[Docket No. 2000-NM-93-AD; Amendment 39-11711; AD 2000-09-03]

Airworthiness Directives; Boeing Model 747-400 Series Airplanes Equipped with General Electric CF6-80C2 Series Engines

**2000-09-03 BOEING:** Amendment 39-11711. Docket 2000-NM-93-AD. Supersedes AD 2000-02-33, Amendment 39-11551.

Electro-Mechanical Brake and CDU Cone Brake Torque Check  
Figure 1

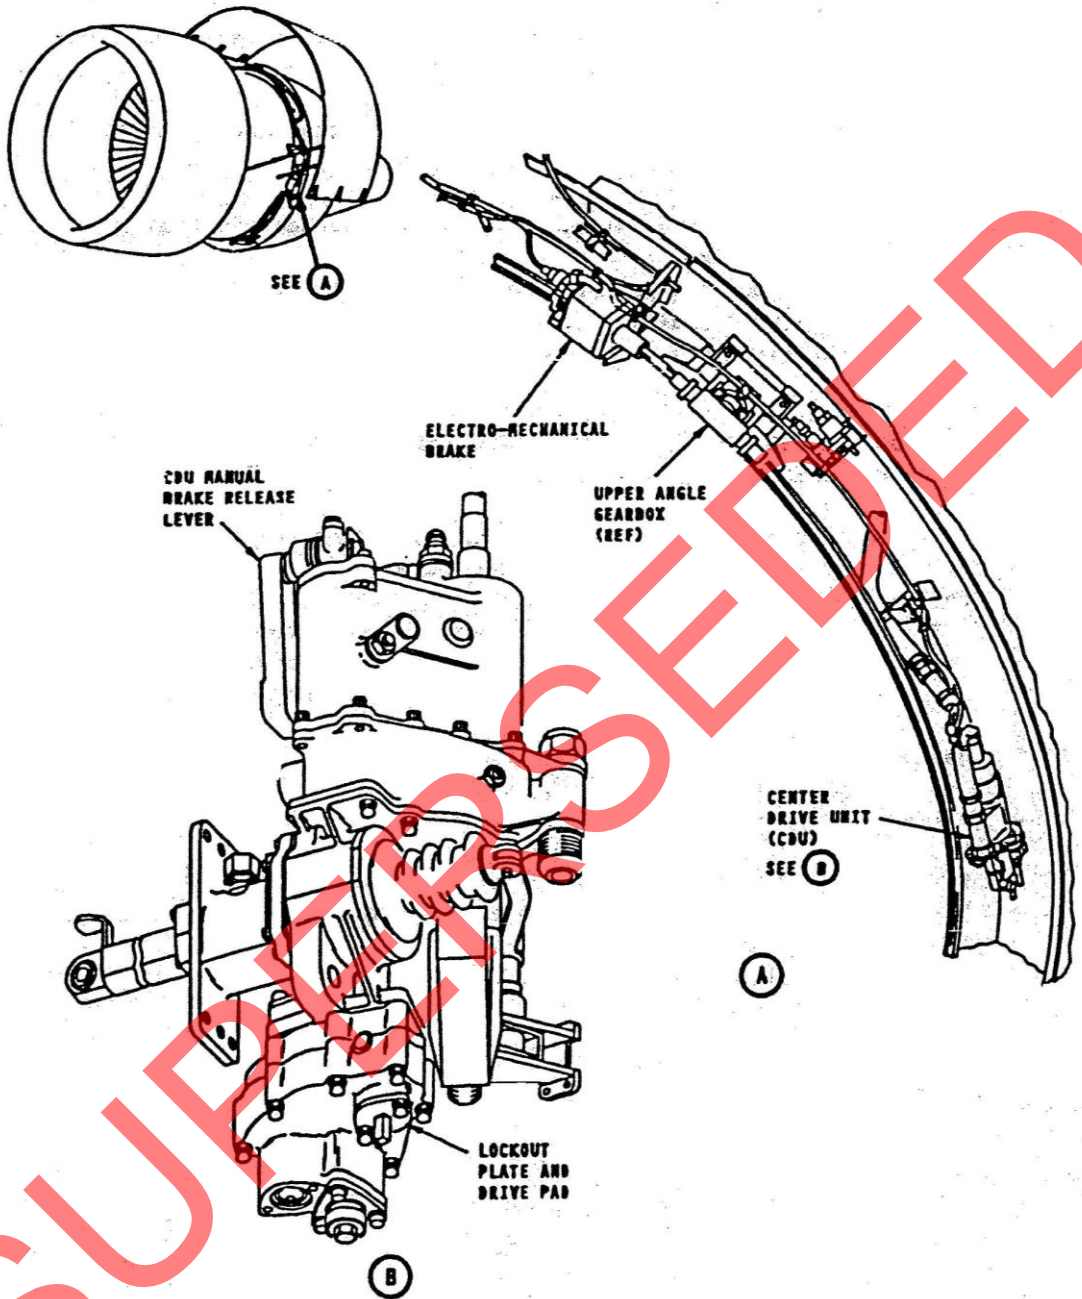
- Completion of the functional test of the CDU cone brake as referenced in the existing AD is ineffective for Model 747-400 series airplanes having a third locking system installed on the thrust reversers. The test for those airplanes requires an additional step to unlock the electro-mechanical brake prior to accomplishment of the functional test of the cone brake of the center drive unit. This step was omitted from the functional test described in the service bulletins and referenced in paragraph (a) of the existing AD. Therefore, Appendix 1 (including Figure 1) has been added to this AD to provide accurate instructions for airplanes that have a third locking system installed. Paragraph (a) of this AD has been revised to reference Appendix 1 (including Figure 1) as the appropriate source of service information for those airplanes.

(2) For Model 747-400 series airplanes equipped with thrust reversers that HAVE been modified in accordance with Boeing Service Bulletin 747-78-2151 or a production equivalent: Perform the test in accordance with Appendix 1 (including Figure 1) of this AD. Repeat the test thereafter at intervals not to exceed 1,000 hours time-in-service.

- (1) Open the fan cowl panels.
- (2) Pull up on the manual release handle to unlock the electro-mechanical brake.
- (3) Pull the manual brake release lever on the CDU to release the cone brake.

- (4) Return the manual brake release lever to the locked position to engage the cone brake.
- (5) Remove the two bolts that hold the lockout plate to the CDU and remove the lockout plate.
- (6) Install a 1/4-inch drive and a dial-type torque wrench into the CDU drive pad.

- (7) Turn the torque wrench to try to manually extend the translating cowl until you get at least 15 pound-inches.

- (8) If the torque is less than 15 pound-inches, you must replace the CDU.
- (9) Reinstall the lockout plate.
